OLD GEORGETOWN BOARD HEARING COMMENT RESPONSES

TO: The Old Georgetown Board
DATE: April 27, 2020
SUBJECT: Comment Responses and Revisions to Initial Concept & Hearing from April 2, 2020
ADDRESS: 1061 Thomas Jefferson Street NW, Washington, DC 20007

HINGHAM INSTITUTE FOR SAVINGS
1061 THOMAS JEFFERSON STREET NW
 WASHINGTON, DC | 05.07.20

1 DIAGRAM OF BASEMENT ADDITION ABIDING BY 8' SIDE YARD REQUIREMENT - NOT FEASIBLE
SCALE: 1/8" = 1'-0"

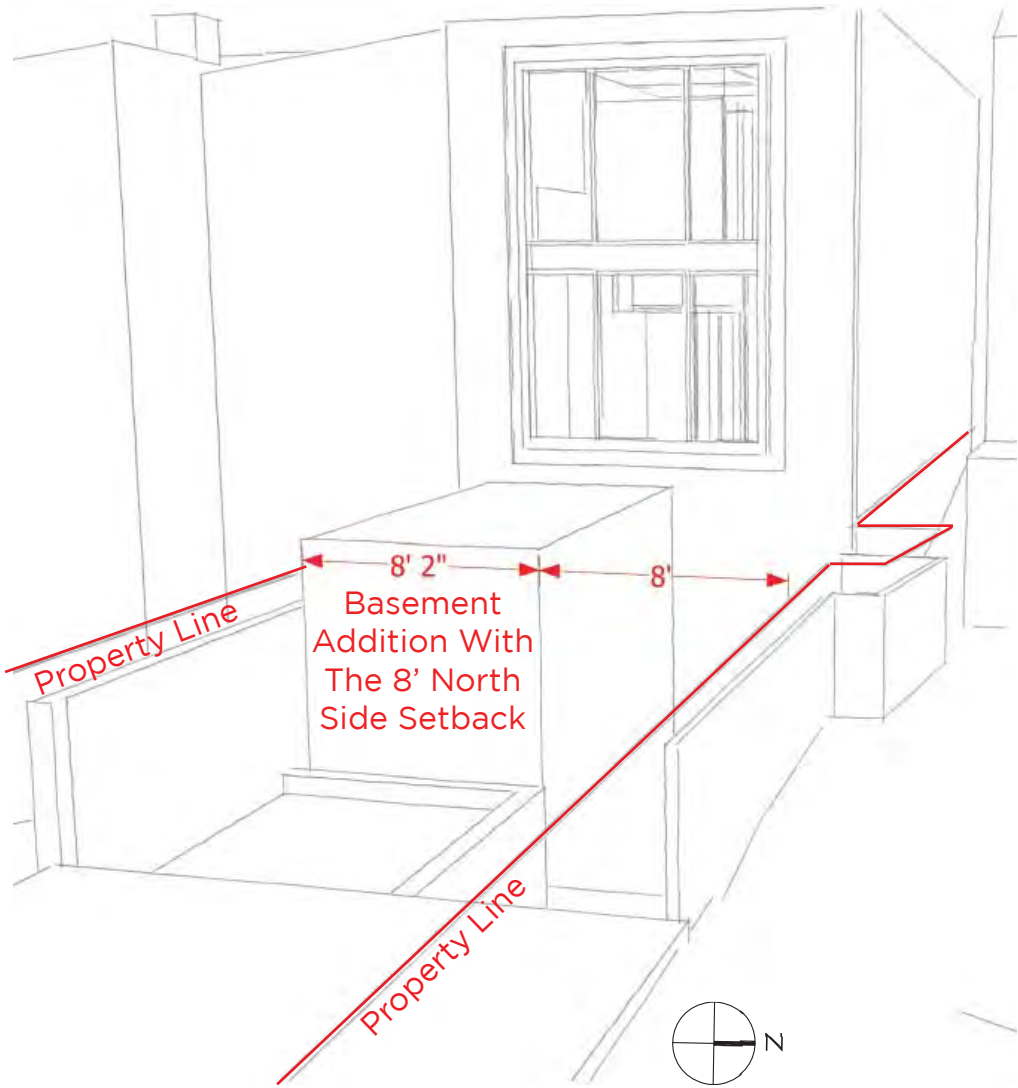
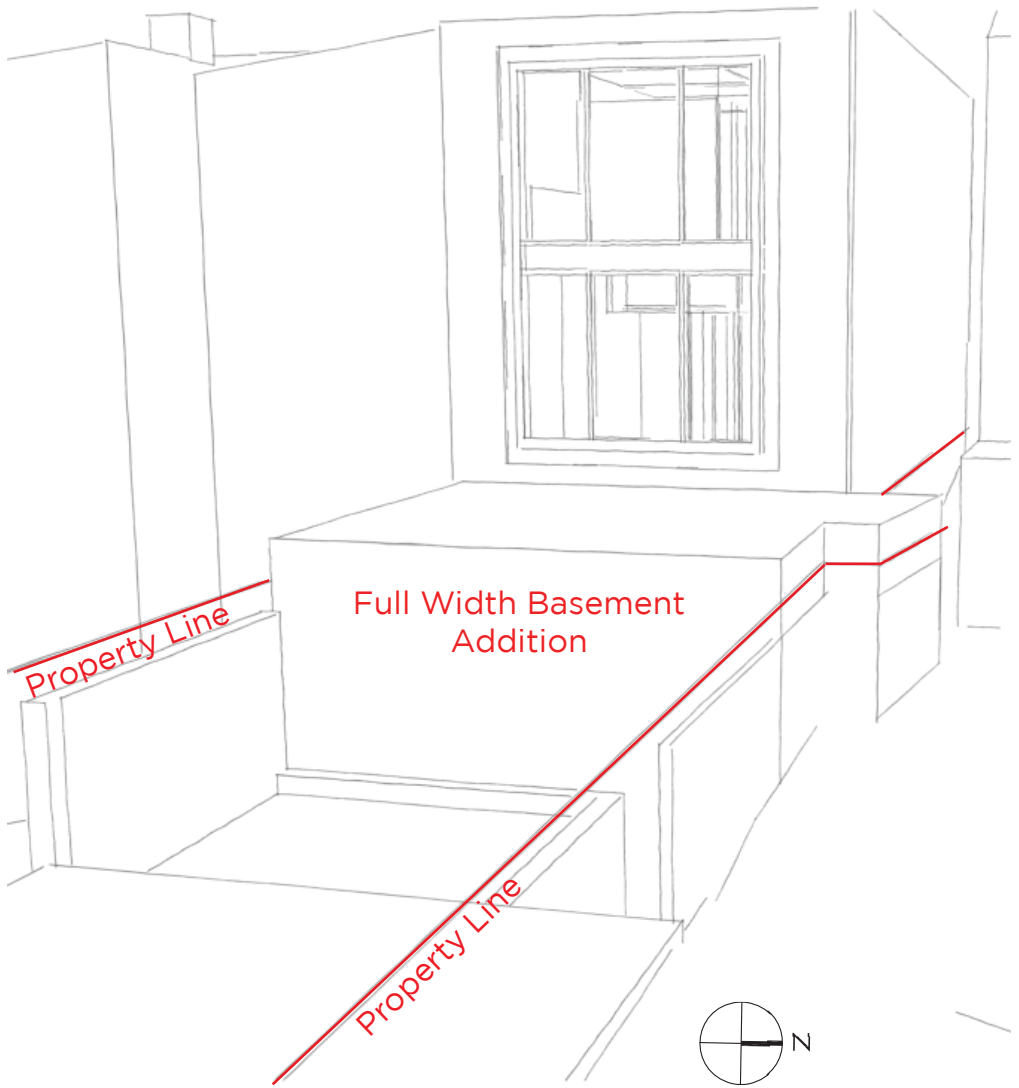
1. The proposed plan should retain the side yard or horse alley on the north, so that it is open from Thomas Jefferson Street through to the rear yard, as this is an important feature of the site. This means that the north angled piece of the addition should be removed from the proposal.
The side yard to the north does not belong to 1061 Thomas Jefferson St. NW. It is located on the property of 1063 Thomas Jefferson St. NW. The side yard is not a feature of this site and the Owners of this property do not have access to it. The proposed one-story rear addition would not alter the public view or character of the side yard from the street. Reference the photographs and diagrams on page 8 and the site survey by others on page 9. Additionally, per zoning regulations for MU-12, the side yard requirement is (0) feet or (8) feet. The current proposal includes (0) feet side yard setbacks. Given the (~16) feet width of the lot, an (8) feet wide setback at the north, would only leave (~8) feet for the width of the addition. This size is not feasible. Reference the diagrams on page 11.

GIVEN THE ~16 FEET WIDTH OF THE LOT, TO ABIDE BY THE ZONING REGULATIONS, AN 8 FEET SIDE YARD AT THE NORTHERN SIDE WOULD DICTATE AN ~8’ WIDE ADDITION WHICH IS NOT FEASIBLE.

2 DIAGRAM OF FULL WIDTH BASEMENT ADDITION - CURRENT PROPOSAL
SCALE: 1/8" = 1'-0"

2 PROPOSED EAST ELEVATION - OPTION 1-TIMBER CURTAIN WALL
SCALE: 1/4" = 1'-0"

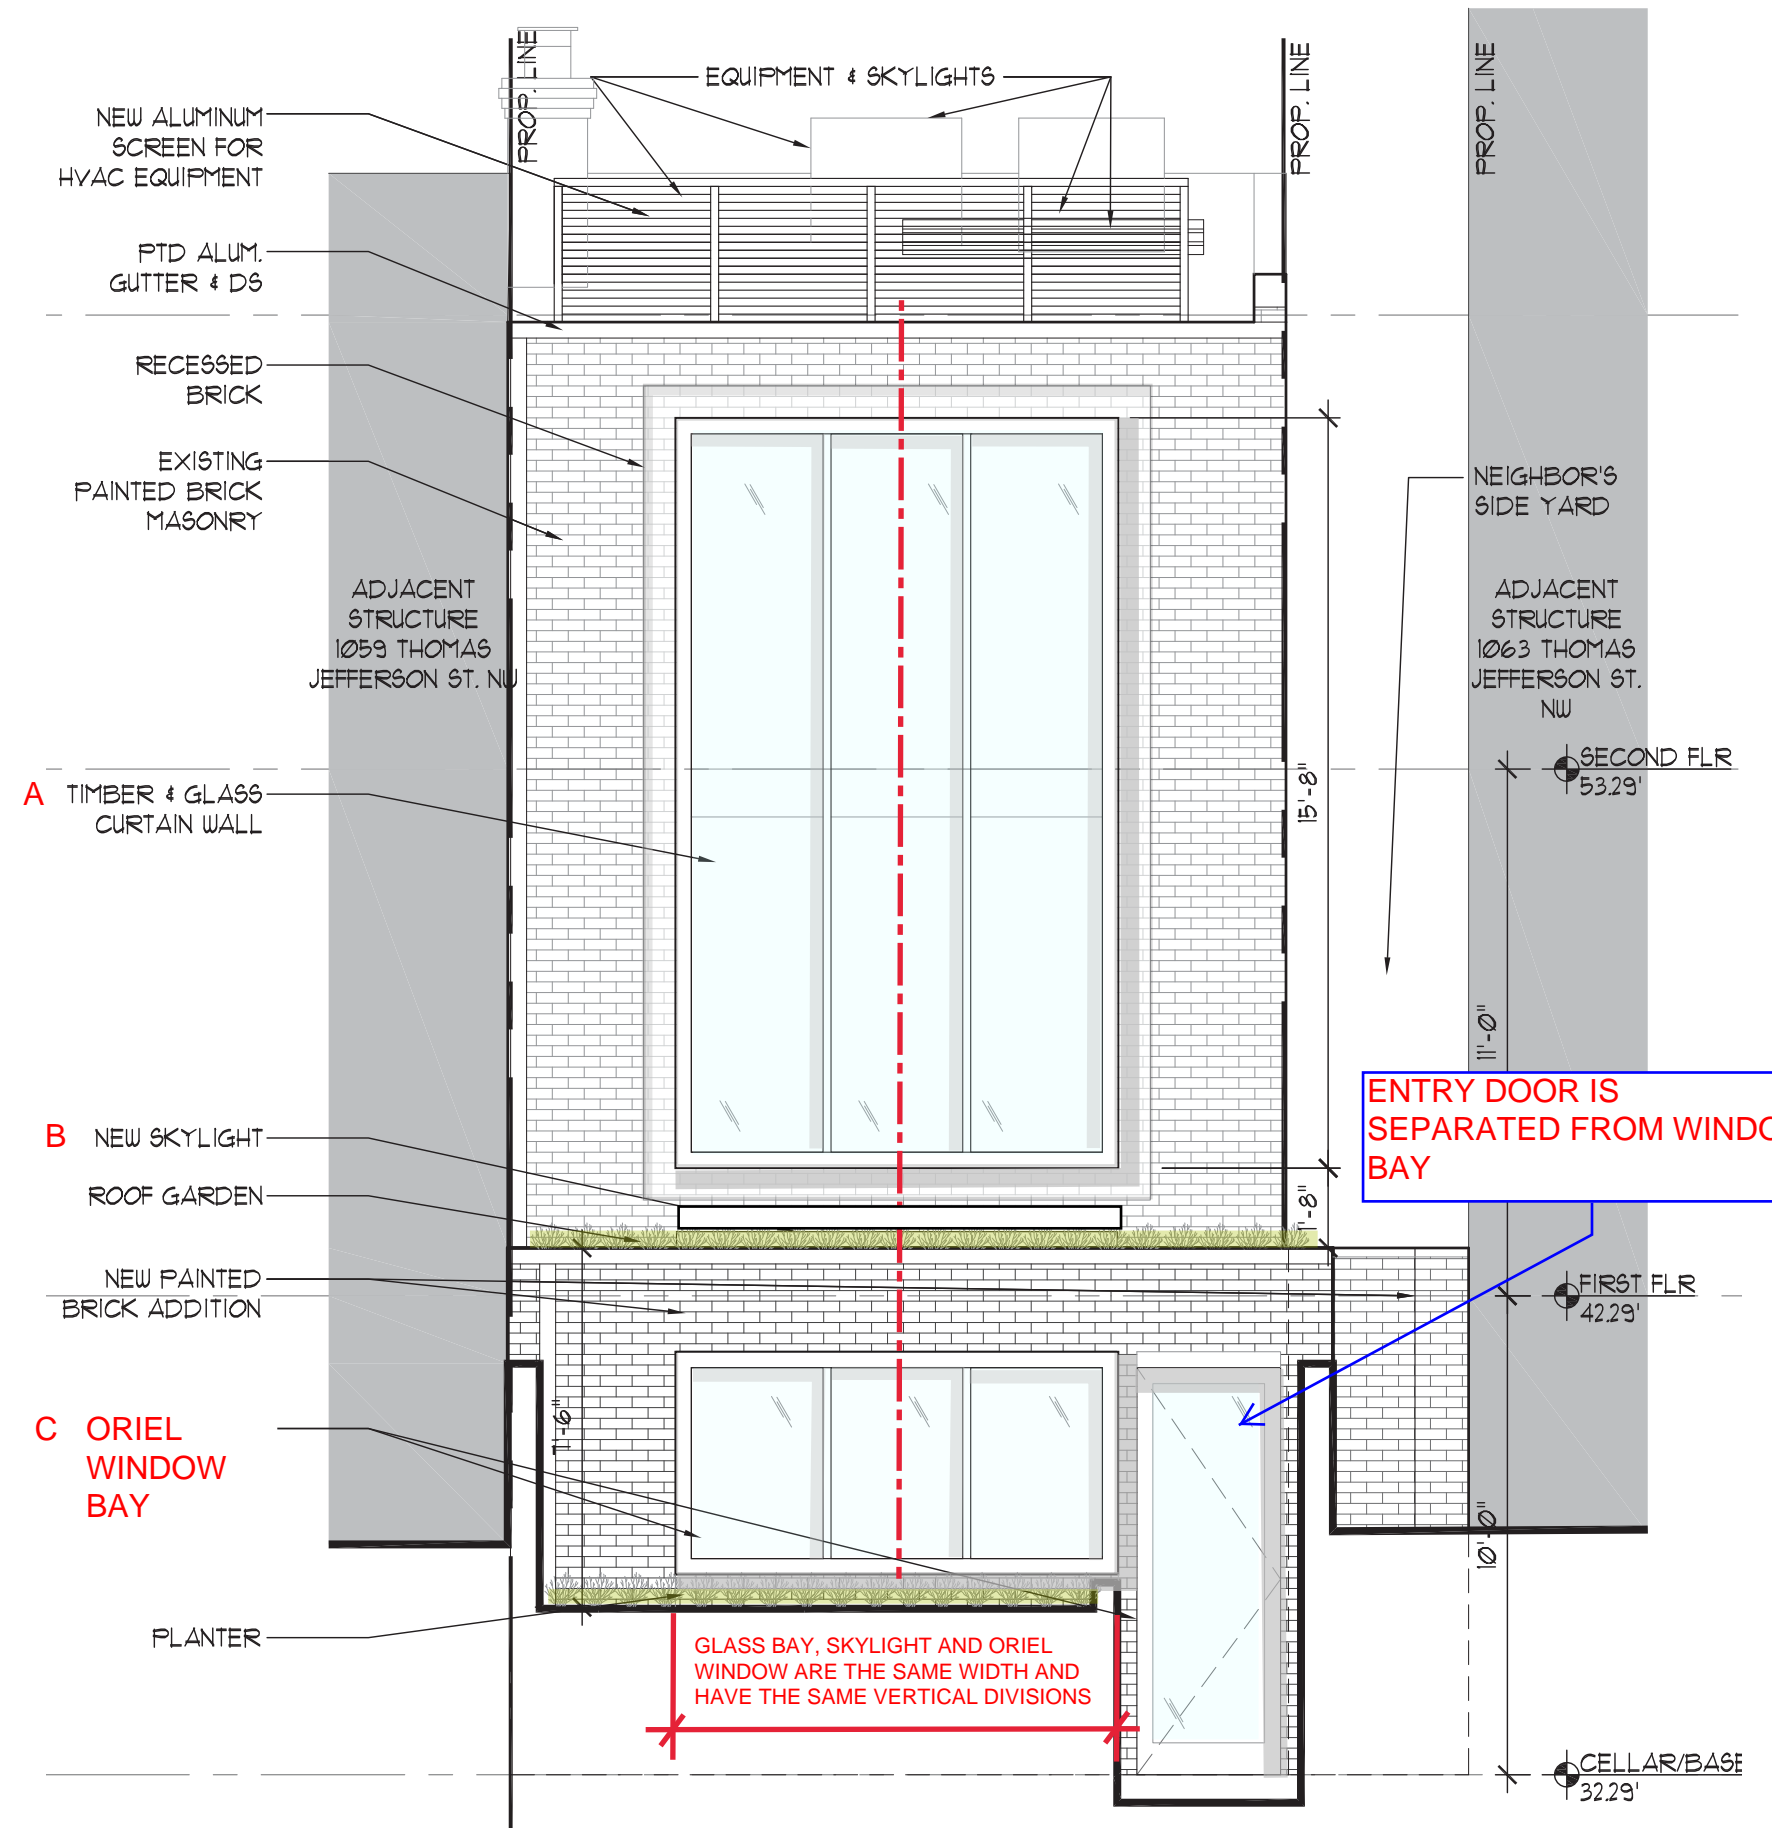
2. The OGB had no objection to the rear bay addition, but found that in elevation, the basement has no relationship to the design above and could be more like an ell to better relate to the site.
Reference revised elevations on sheets 32 and 33.
The design of the bay and addition have been revised to unify the whole rear yard elevation:

3. Include some different fenestration options for the rear elevation design. This rear elevation is highly visible and if a glassy addition is desired, it should be a true modern design. Consider spandrel glass and better proportions, or; consider reducing the glazing and using a material palette that is more sympathetic to the adjacent C&O Canal. The OGB would also like to see studies of the proposed design as viewed from the mule yard, behind the property.
Per the response to comment #2, the two fenestration options provided are a more contemporary approach to the rear elevation. Each of the glass openings are surrounded by solid metal frames constructed to project from their surrounding surfaces. This will create some shadow and relief on the rear facade and unify the all of the newly constructed elements. Reference page 34 for views from the mule yard.

1. All three new glass elements (2 story bay, skylight and oriel bay) are the same width and vertical glazing proportions.
 2. The rear yard entry door in the addition is offset from the ground level window bay to allow the primary glass elements to align with each other.

1 PROPOSED SECTION E-W
SCALE: 1/8" = 1'-0"

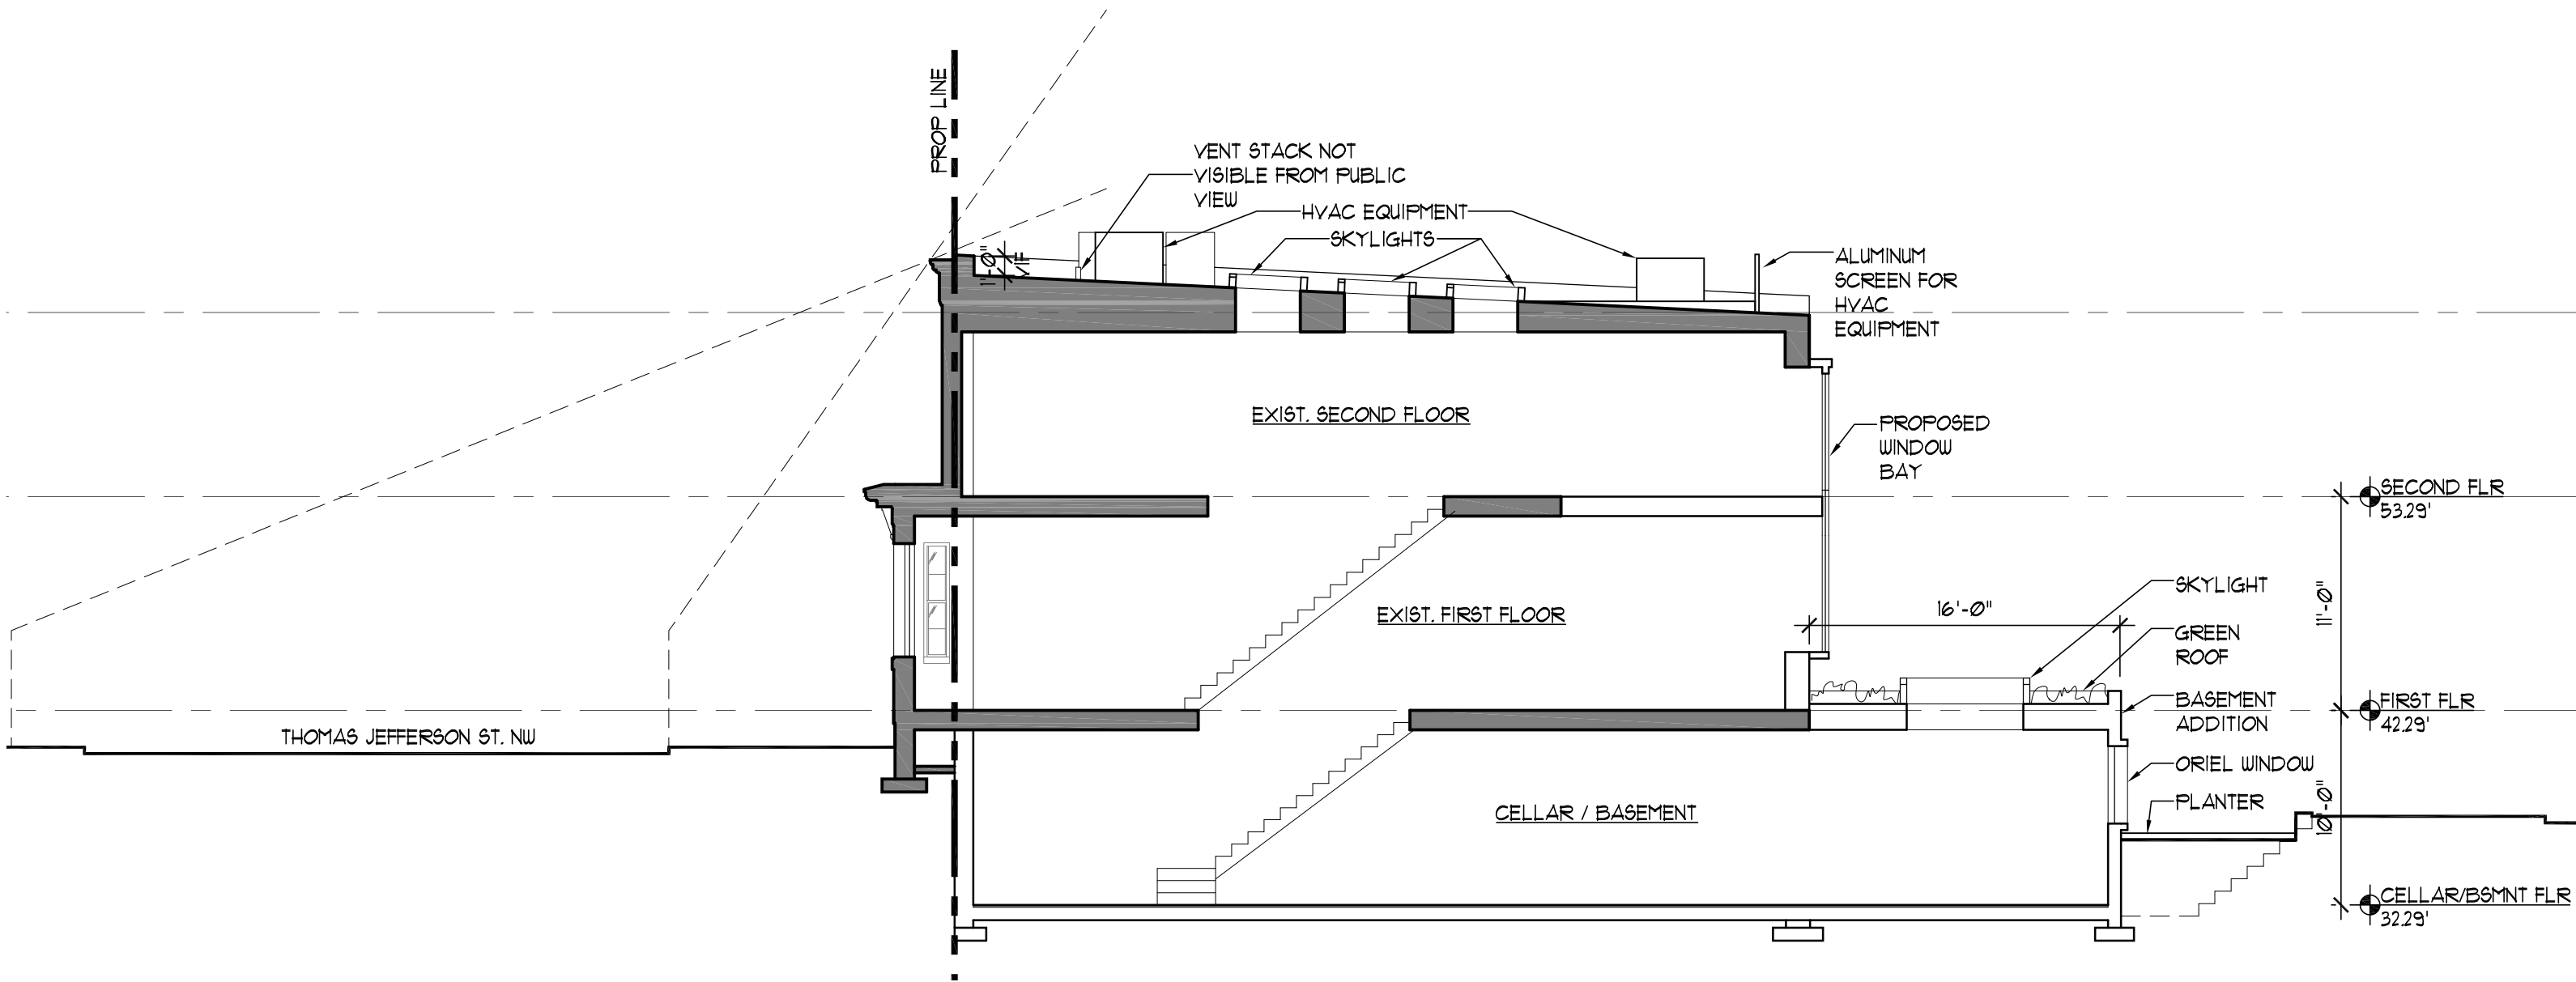
4. Please show that any vent stacks proposed for the basement level bathrooms are not visible from Thomas Jefferson Street, or if minimally visible that they will be painted or clad as opposed to bright white.

An 8" stack has been included in the section. This stack will not be visible from public view. Reference page 37 for the proposed section.
